CONTRACT CHANGE ORDER

CCO: 240 Suppl. No. 0 Contract No. 04 – 0120F4 Road SF-80-13.2/13.9 **FED. AID LOC.:**

The following revised plan sheets detail the changes addressed in this change order: 748R2, 749R2, 752R4, 753S1R3, 753S3R1, 769S1, 769S2, 777R2, 778S2R1, 779R1, 786R2, 788R1, and 788S1 (of 1204) as shown on sheets 2 through 14 of this change order.

SAN FRANCISCO OAKLAND BAY BRIDGE
EAST SPAN SEISMIC SAFETY PROJECT
SELF-ANCHORED SUSPENSION BRIDGE (SUPERSTRUCTURE & TOWER)

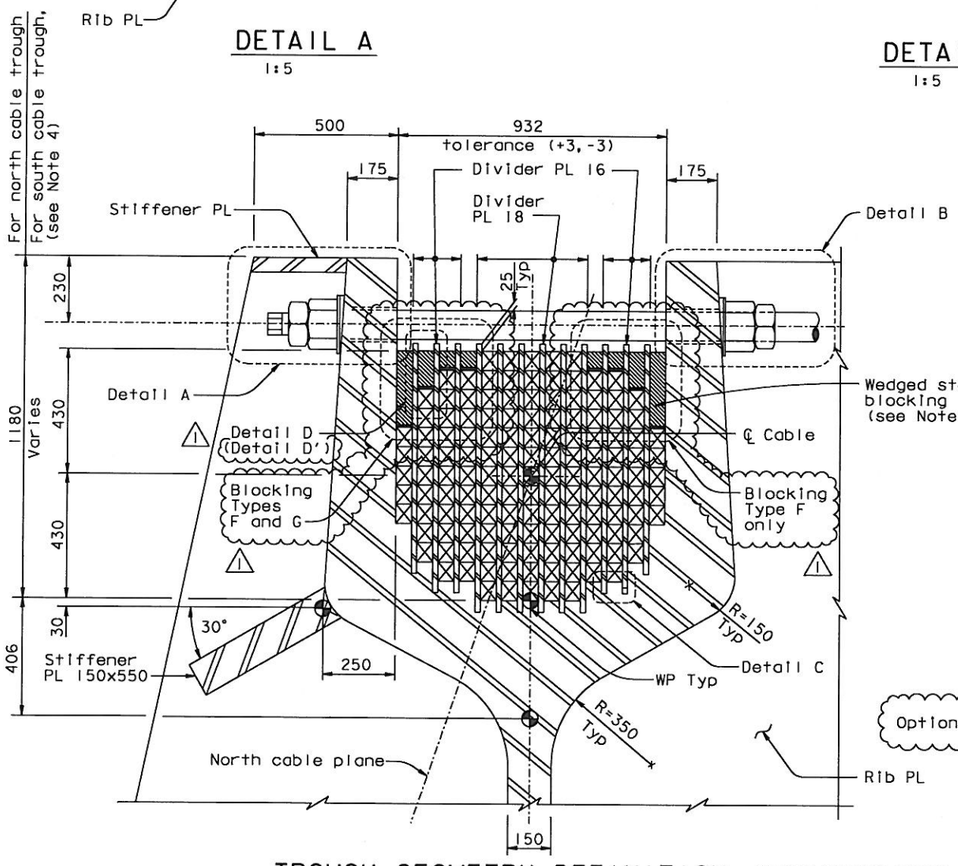
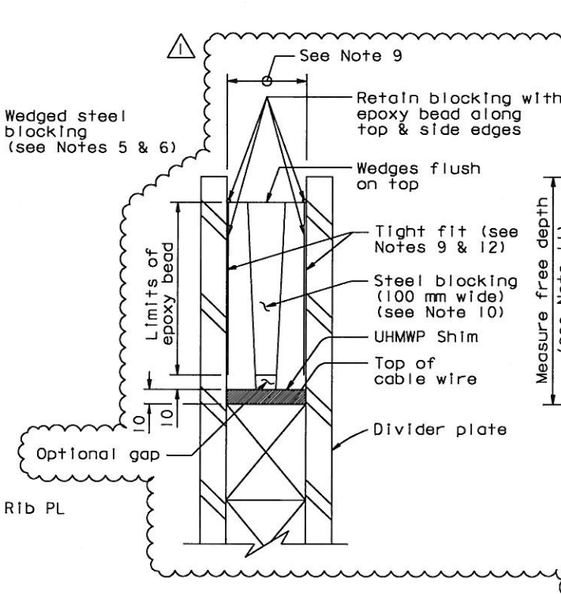
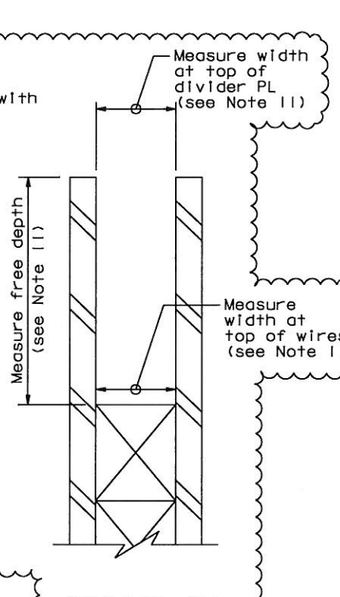
5. Wedged steel blocking layout shall be as shown on "Tower Saddle Details No.5B" sheet. Steel shall be ASTM A572. All surfaces of steel shall be primed. ⚠1

10. At the Contractor's option, the steel blocking may be fabricated in several pieces. The taper of any piece shall not exceed 1:20. Provide adhesive between surfaces of blocking pieces. ⚠1

11. Tower Saddle survey (see Detail D'):
    - Measure compartment width at top & bottom
    - Measure compartment depth
    - Measure at each blocking sections Type F & G

ELEVATION OF TYPICAL EAST SADDLE (IN THE PLANE OF CABLE) (See Note 6)

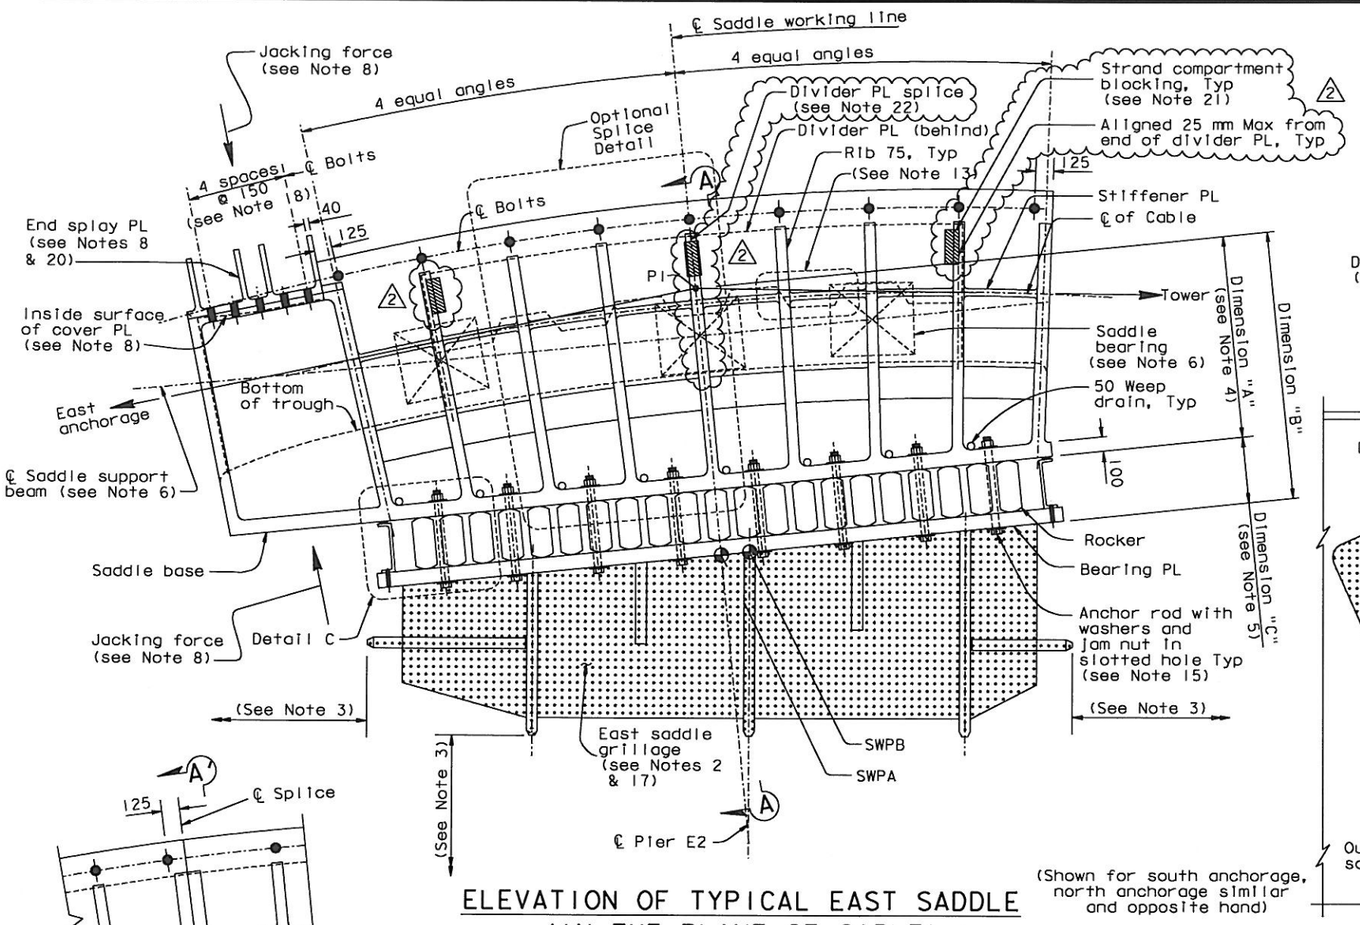
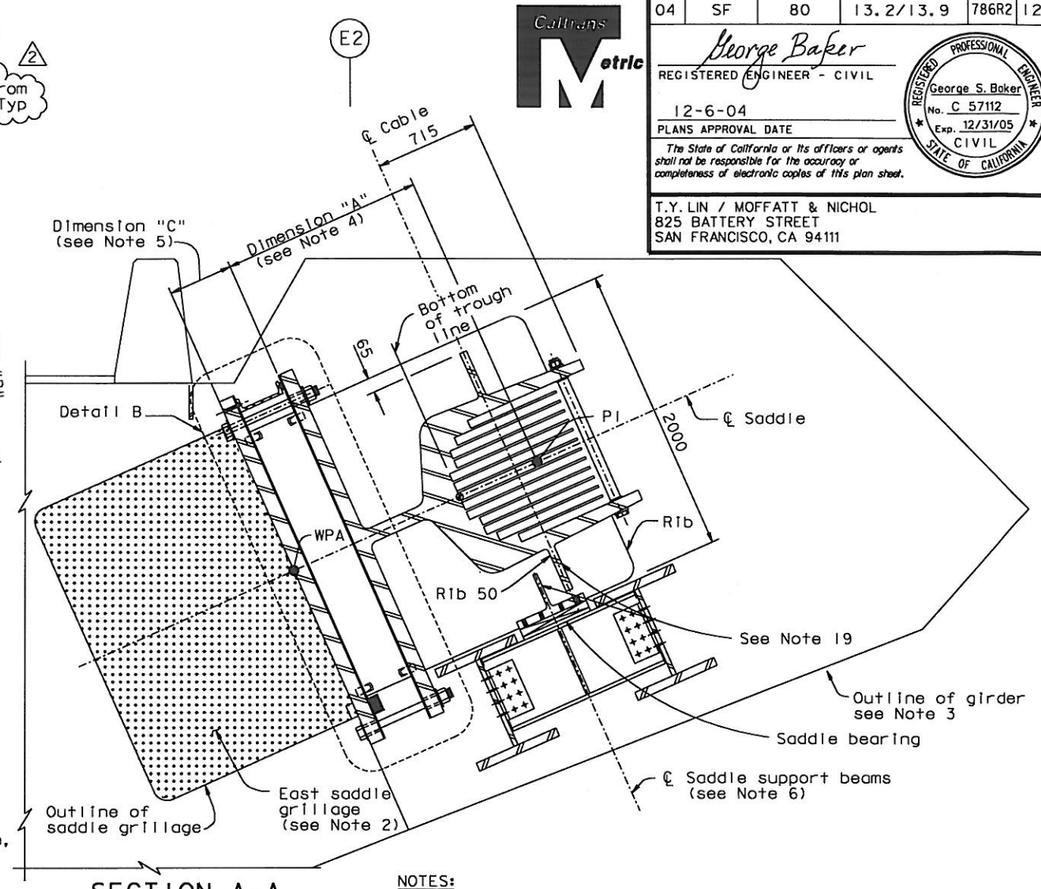
2 21. The Contractor shall fabricate and install new blocking. For typical blocking, see Section A-A on "East Saddle Details No.5" sheet. For typical blocking details, see "East Saddle Details No.5A" sheet.

LAYOUT OF OPTIONAL HARDWOOD BLOCKING (See Note 7)

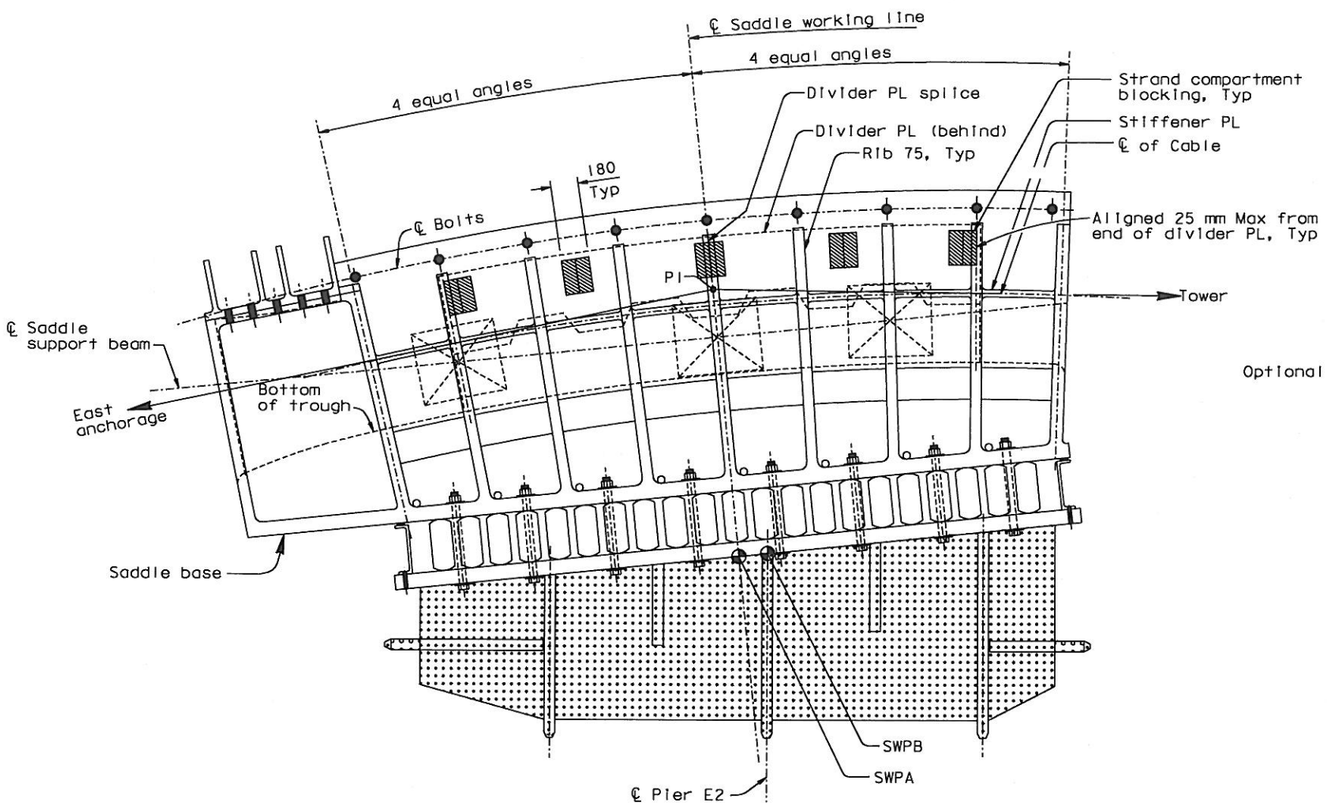
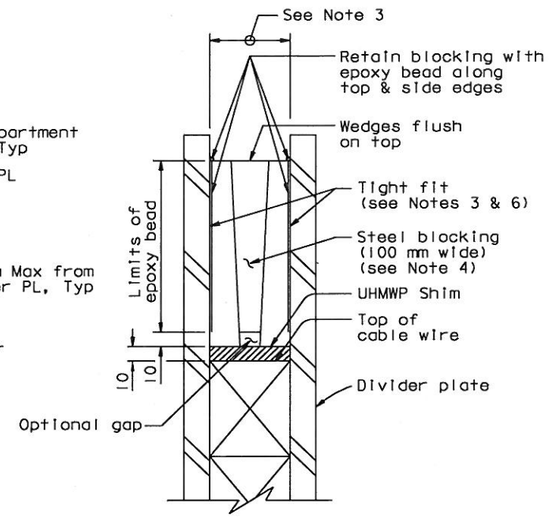
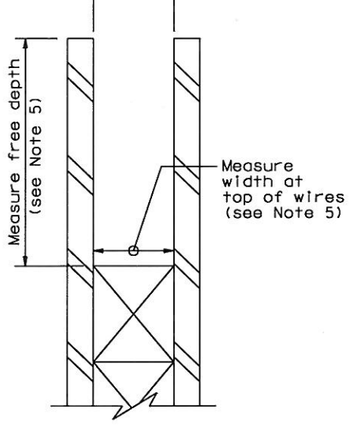
1. Wedged steel blocking layout is shown on "East Saddle Details No. 3" sheet.
2. Steel shall be ASTM A572. Surfaces of wedged steel plates against the divider plates shall have PTFE film (0.5 mm thick). All surfaces of steel shall be primed.

4. At the Contractor's option, the steel blocking may be fabricated in several pieces. The taper of any face shall not exceed 1:20. Provide adhesive between surfaces of blocking pieces.

5. East saddle survey (See Detail D')
   - Measure compartment width @ top and bottom
   - Measure compartment depth
   - Measure @ each blocking section
   - At each section measure all compartments
